RE: Construction Quality Assurance Certification
Report – MSW Phase 3
White Oak MSW Landfill Permit # 44-07
Haywood County, North Carolina

**CONSTRUCTION QUALITY ASSURANCE
CERTIFICATION REPORT
MSW PHASE 3**

RE: Construction Quality Assurance Certification Report Revision
White Oak Landfill, Phase 3 Expansion
NC DENR Permit #44-07
Haywood County, North Carolina
JEI Project No. 801.0900.11, Task 01

PROJECT: White Oak LF - Phase 3
PROJECT NO.: 07518
DESCRIPTION: LF Section over Pipe Repair
CALCULATED BY: WNS CHECKED BY: _____
DATE: 11/10/10 SHEET NO. 2 OF 2

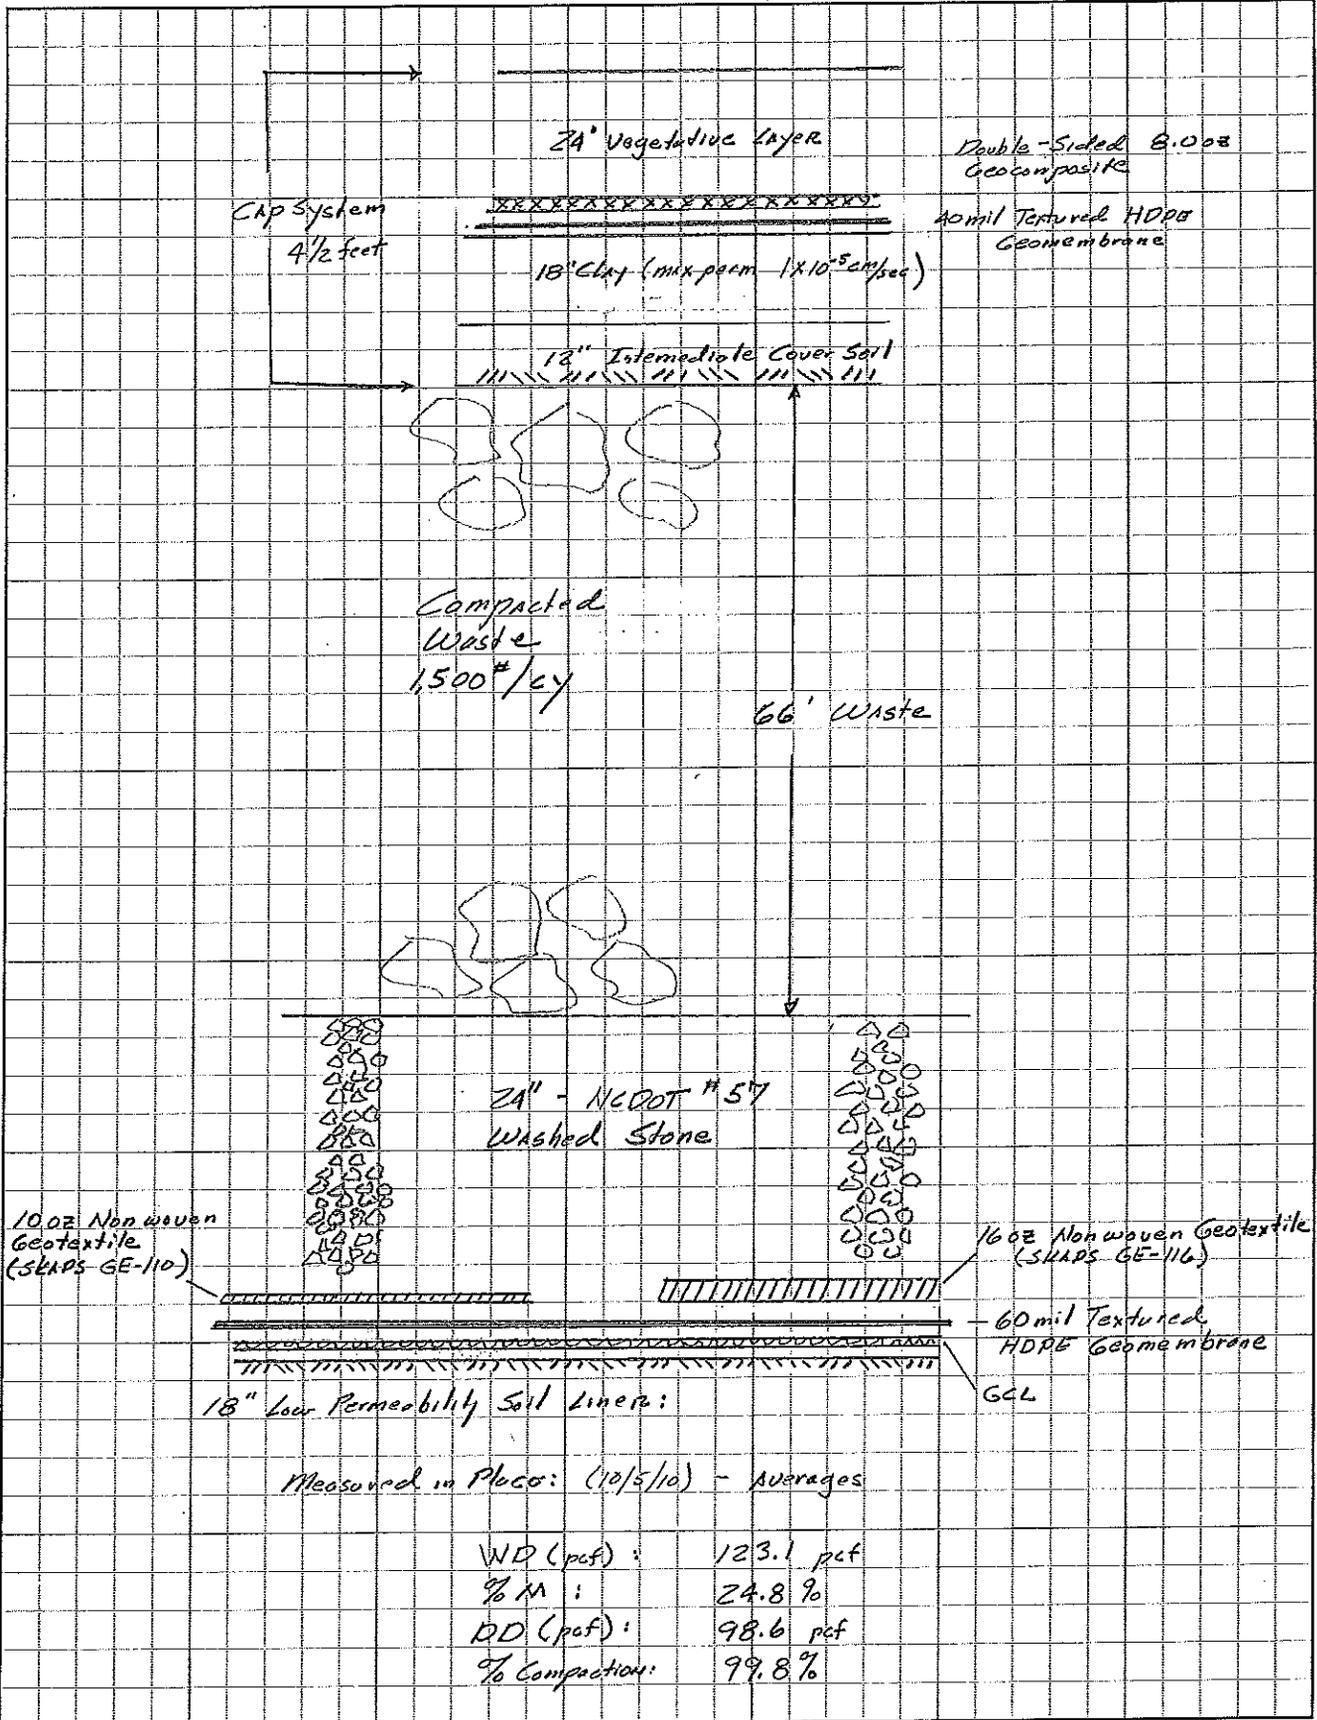
1. Minimum Factor of Safety of 1.5.
2. Thoroughly explain, in detail, any assumptions, formulas, calculations, etc. List all reference documents, papers, etc.
3. Technical Specifications for 60 mil Textured HDPE Geomembrane, SKAPS 1600 Nonwoven Geotextile should be those approved as a part of the submittal process.
4. Technical Specifications for the SKAPS 1000 Nonwoven geotextile should be those submitted as used as a part of the pipe repair.
5. Gradation for the NCDOT #57 washed stone should be the same as approved as a part of the submittal process.

Provide certified analytical analysis/data that the 1000 nonwoven geotextile will meet the physical protection requirements for the 60-mil geomembrane from the materials installed/placed directly above (Stone drainage layer & coarse mass). Must have a minimum factor of safety of 1.5.

Attached are the hardcopies for the evaluation of the 10 oz/sy geotextile used in the repair of LP-4. The evaluation was performed by Joyce Engineering on behalf of Thalle/Hallaton. The evaluation demonstrates that the 10 oz/sy geotextile provides a factor of safety of 3.2, more than twice the minimum required by McGill Associates. A copy of this evaluation was forwarded on 12/15/10 for your review and comment. Since we have not received any comment, it is understood the evaluation is acceptable.

$$\text{Factor of Safety} = Pallow/Preqd = 3.2$$

Therefore, use of a 10 oz/sy geotextile produces an adequate factor of safety for liner puncture due the the given loading
